Glyn Rhonwy Pumped Storage (EN010072)

PINS Reference: 10031993 Mike Vitkovitch

Deadline 6 – Submission

4 July 2016

Q6 Temporary Slate Tip

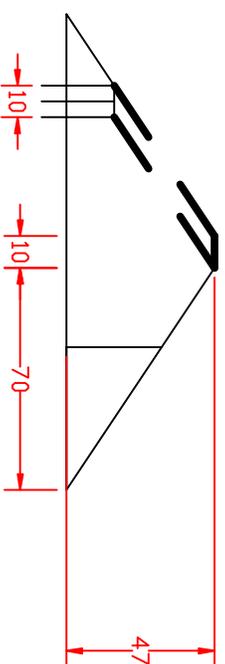
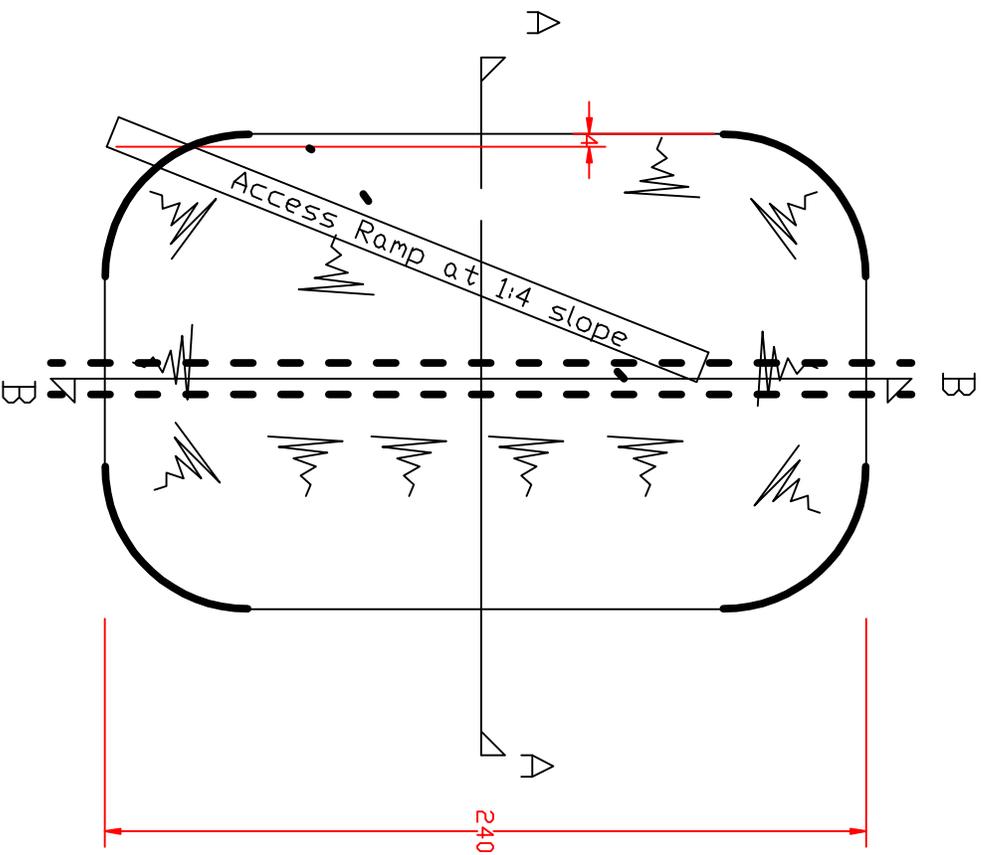
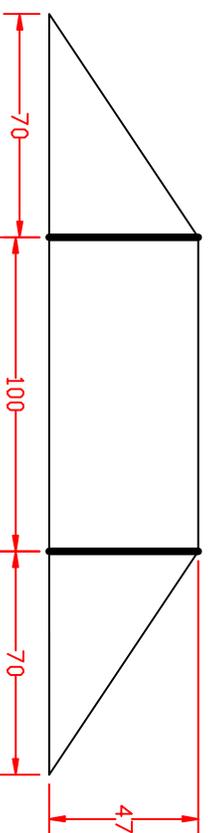
I attach a scan of an overlay on the Applicant's drawing titled 'Q6 Temporary Tip MV' illustrating its size and location. The possible width of this stockpile is limited by the sides of the Q6 excavation and the adjoining garage/property to the north. The length is limited by the outcrops of bedrock

below the Clegir Road and the Order limits. It will be a high and dominating structure visible above the Lake View' restaurant and the A4086.

Furthermore no assessment of the noise and dust created from the working of this huge tip have been made by the Applicant. His Q6 noise pattern ignores the loading and tipping of wagons, noises that cannot be mitigated. The height of the tip means that a 360 degree area will be affected by the noise, affecting Llanberis village and all the properties up and down the lake. He currently suggests a narrow cone of noise affecting Fachwen. This is a complete and self evident underestimation of reality achieved by not showing the full size of his works. If consent is given for this project , the working on this tip must not be allowed to carry on outside of the working day. Although an 'average' noise level may not be exceeded it will be the frequent, but randomly timed scrapping out of truck bodies and crashing of slate waste that will keep people awake. Even using a 'conveyor' the material will need to be loaded onto trucks and moved to be deposited in each area of the tip.

It is impossible to prevent the surface of a tip of this size from drying out and as all the material is 'as dug' it will be covered in dust. This will dry and blow in which ever direction the wind is blowing. The Principal Contractor will be unable to control this with tip side slopes of nearly 100m length.

Given my earlier Deadline 5 submission on the effects of over break and bulking factors, it is apparent that there will be insufficient space to safely store the surplus slate prior to transportation. The scale of work involved in this application is unsuited to the proposed location.

- Area of side slopes $70 \times 47 = 3290 \text{ sqm}$
- Area of centre $100 \times 47 = 4700 \text{ sqm}$
- Area of Cross Section BB = 7990 sqm
- over 10m centre width on AA = $79,900 \text{ cubic metres}$
- Area of side slopes on AA $70 \times 47 = 3290 \text{ sqm}$
- Additional side volume on Section AA is $100 \times 3290 = 329,000 \text{ cubic metres}$
- Plus 4 conical corners totalling $70 \times 70 \times 47^2 / 3 = 241,266 \text{ cm}$
- Maximum possible capacity of temporary stockpile $650,167 \text{ cubic metres}$
- without any reduction for access track volume.
